LAND USE APPLICATION SUMMARY

Property Location: 315 Nicollet Mall
Project Name: 365 Nicollet
Prepared By: Kimberly Holien, Senior Planner, (612) 673-2402
Applicant: The Opus Group
Project Contact: Matt Rauenhorst
Request: Final Plat.
Required Applications:

Preliminary Development Review Report

Tracking Number:	PDR 1001336
Applicant:	OPUS GROUP 10350 BREN ROAD MTKA, MN 55343
Site Address:	315 NICOLLET MALL
Date Submitted:	14-JUL-2015
Date Reviewed:	22-JUL-2015

THREE SIXTY FIVE NICOLLET ADDITION

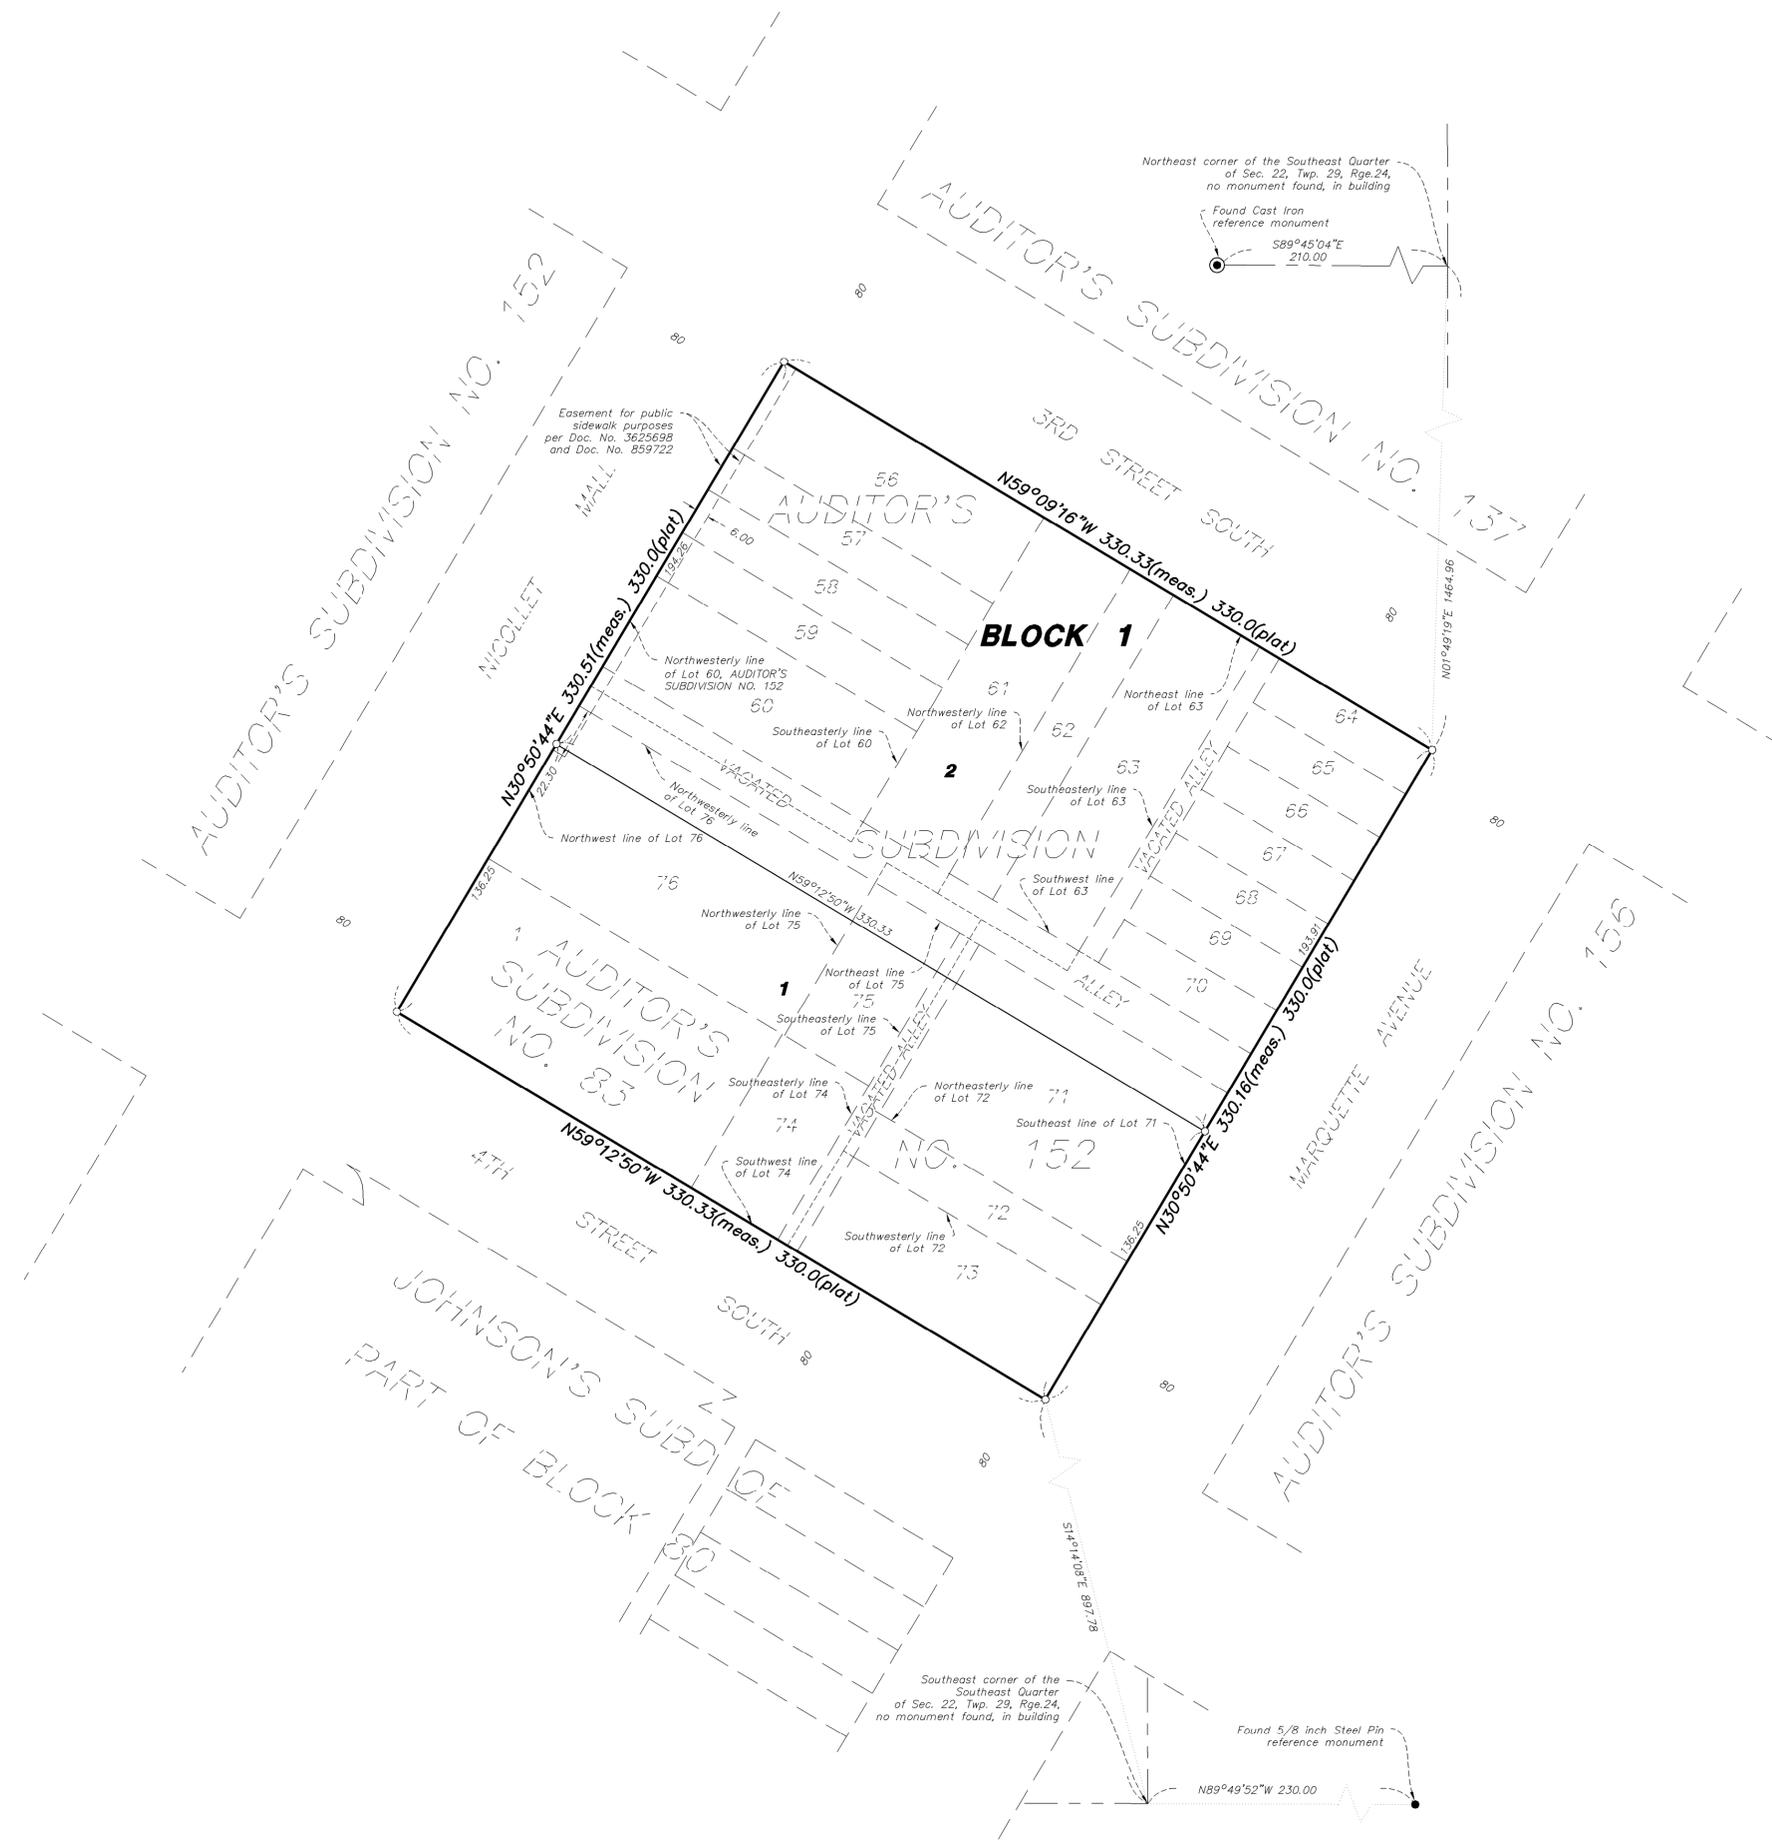
- The project requires an application for site plan review and variances to the NM, Nicollet Mall Overlay District standards. Additionally, you have elected to plat the site. To pursue the plat, the following items need to be addressed:
 - The plat needs a title at the top

- The proposed legal descriptions look like they should be: Lot 1, Block 1, Three-Sixty Nicollet Addition to Minneapolis. That needs to be reflected on the application worksheet.
- You cannot have any development on an outlot, including parking. If the intent is for the parking to stay on the north half of the block, that will need to be platted as Lot 2.
- As an alternative to platting you could split the parcel by doing a minor subdivision to create two lots.
